SUBJECT: Addendum No. 2
City of Fort Oglethorpe
Municipal Maintenance Facility Improvements

ADDENDUM NO. 2

MUNICIPAL MAINTENANCE FACILITY IMPROVEMENTS

CITY OF FORT OGLETHORPE FORT OGLETHOPRE, GA CTI PROJECT NO. G23010

JOB NO. G23010
ISSUE DATE 02/12/2024
DRAWING NO. S-206.1

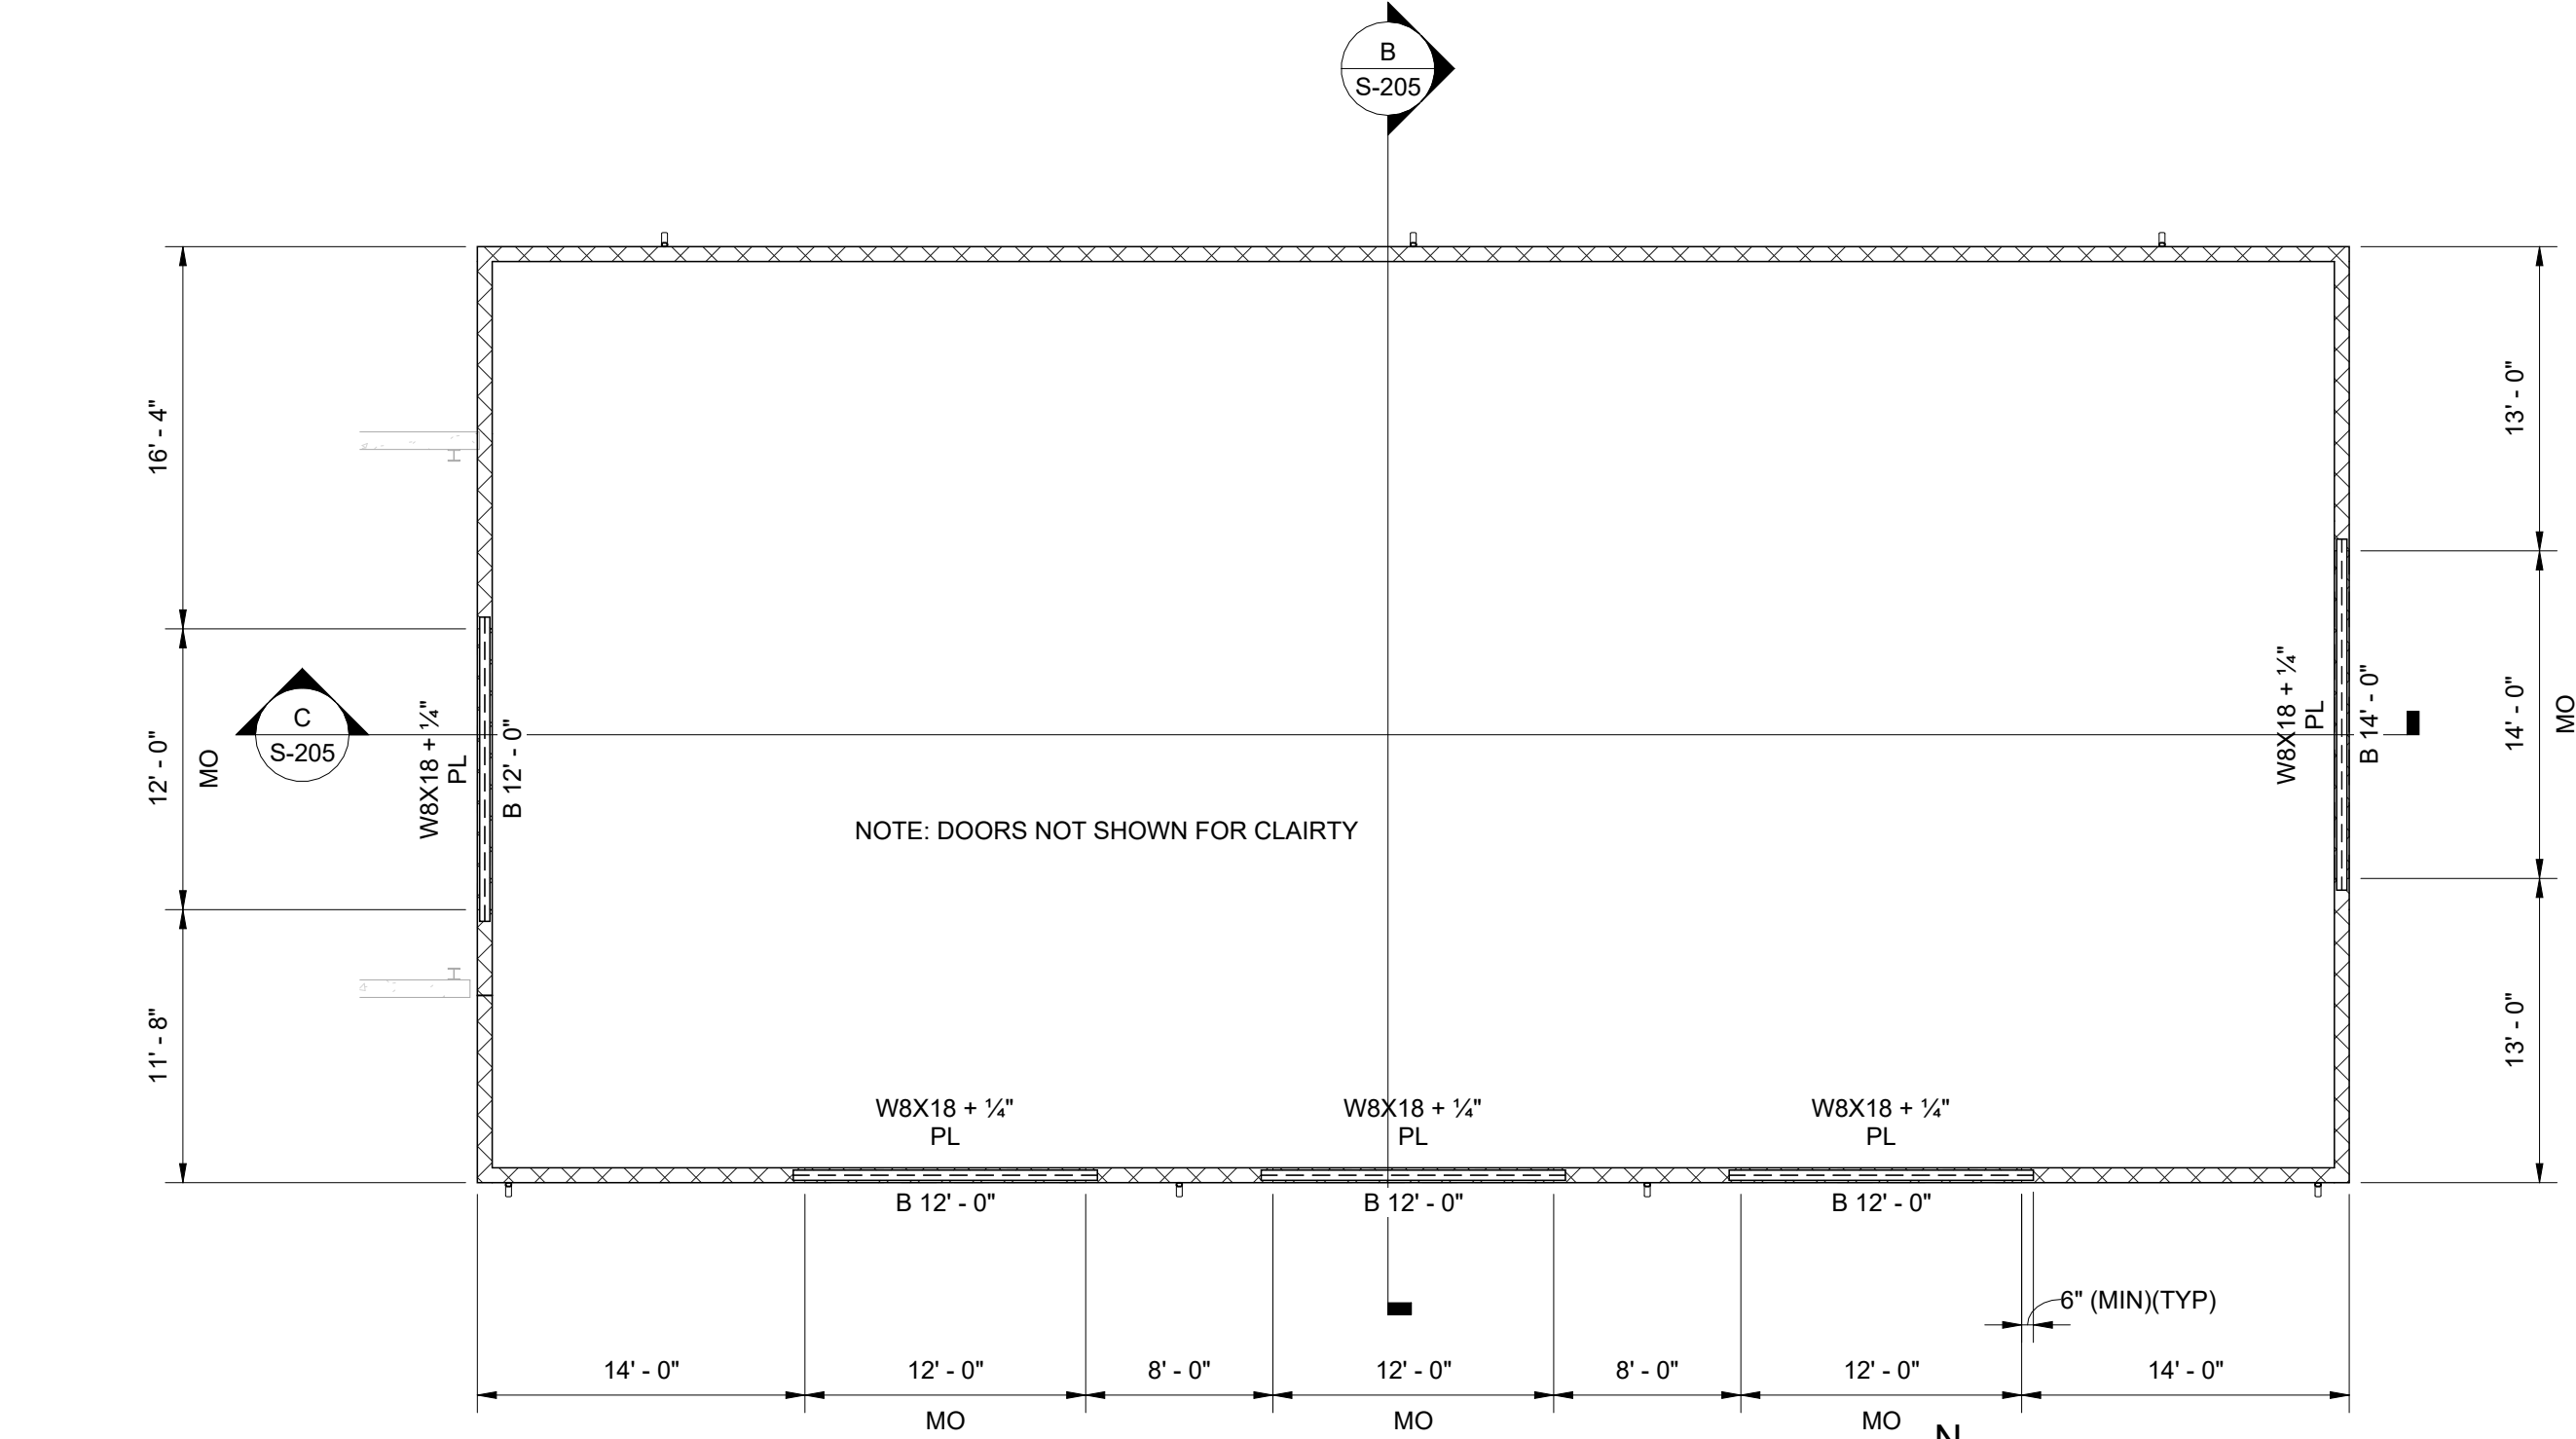
- A9. The note on sheet S-206 has been revised to state the 1x4 PAINTED TO MATCH CEILING and the 1/2" PLYWOOD CEILING - PAINTED WHITE. The Painting Specification has been revised and is included with this Addendum.**

- A28. See revised paint spec in this addendum.**
- Q29. CMU walls are to be foam filled, insulated per Spec 04 20 00-7, 2.10 and 07 21 00-2, 2.1.E. Detail S-205,3 does not depict any CMU block fill. This would be argued by another contractor, potentially, if not clearly called for in the drawings. We would like to highlight that it is not shown here and either be stated as required or not required per specifications.

- A29. The CMU walls are to be foam-filled. A note has been added to sheet S-206.1.**

1. DELETE Drawing No. C-201 and REPLACE with Drawing No. C-201.1
2. DELETE Drawing No. S-206 and REPLACE with Drawing No. S-206.1
